**Wood-Pawcatuck Wild & Scenic Rivers  
Stewardship Council**  
203 Arcadia Road  
Hope Valley, RI 02832  
401-539-9017

RE: 'Stone Ridge at Hopkinton' Photovoltaic Solar Energy System Master Plan

Appendix I: Map

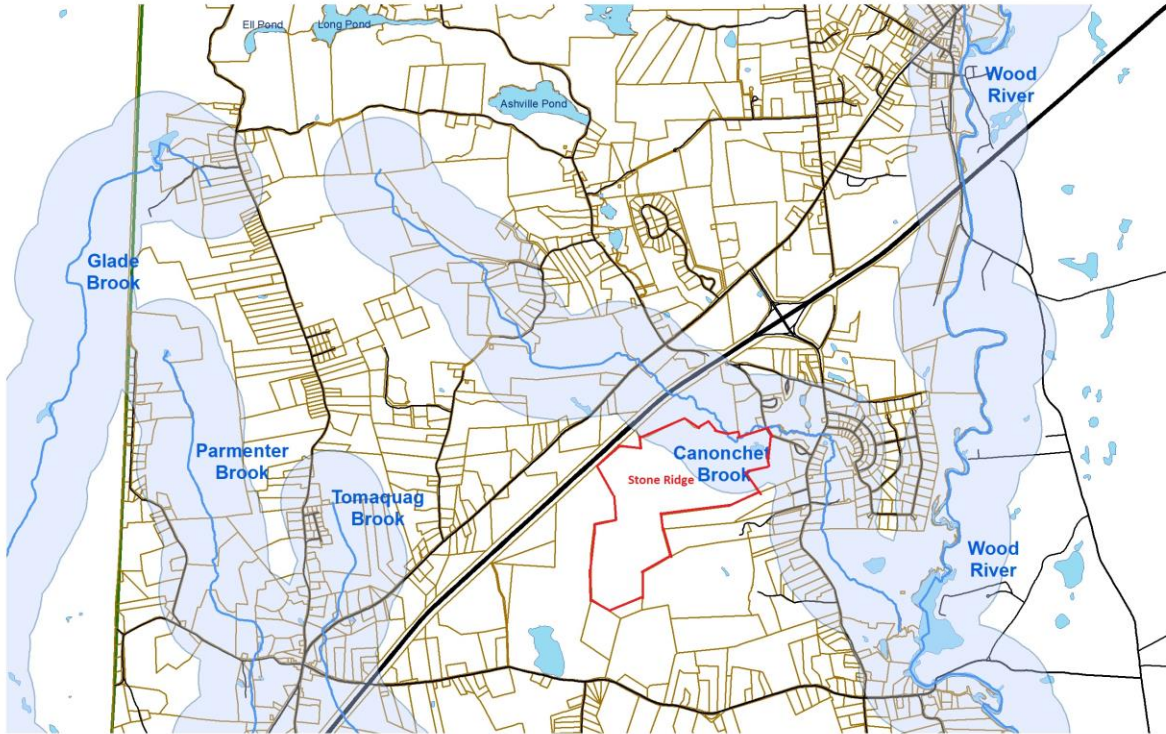
- Destruction of forest cover: Forests serve as natural filters and are the most effective land cover for maintenance of water quality and quantity, providing a quantifiable economic benefit by filtering sediments and other pollutants from the water in the soil before it reaches a water source. Large tracts of intact forested land are particularly valuable to preserve. Tree cutting should be avoided to the maximum extent possible.
- Protection of Canonchet Brook: any project should be designed so as to maintain a quarter mile of primarily undisturbed, naturally vegetated buffer around Canonchet Brook. (See Appendix I: Map).

Should the PSES Master Plan be approved by the Planning Board, we encourage the Planning Board, in addition to minimizing disturbance within the ¼ mile area alongside Canonchet Brook, to address any

potential impacts to the Wild and Scenic River values through appropriate mitigation measures and controls. Site plans should address run-off from the site and surrounding area during and after construction considering seasonal and temporal factors. Storm water plans should assure all residues and/or sediments are captured and do not reach water bodies. Water quality of Canonchet Brook should be monitored frequently prior to, during, and after construction of the PSES. If the water quality tests indicate a negative trend the developer should be required to take measures to prevent further water quality degradation. We can provide the Planning Board with further guidance as to frequency and type of water sampling if desired. Appropriate scenic buffers should be detailed in the PSES Master Plan to blend with the existing scenic value of the surroundings either by maintaining the natural vegetation where possible and/or including additional buffers, strategically planted and selected, where needed to screen the entire PSES site. In addition, wildlife habitat protection should be maximized by minimizing forest clearance and stone wall removal.
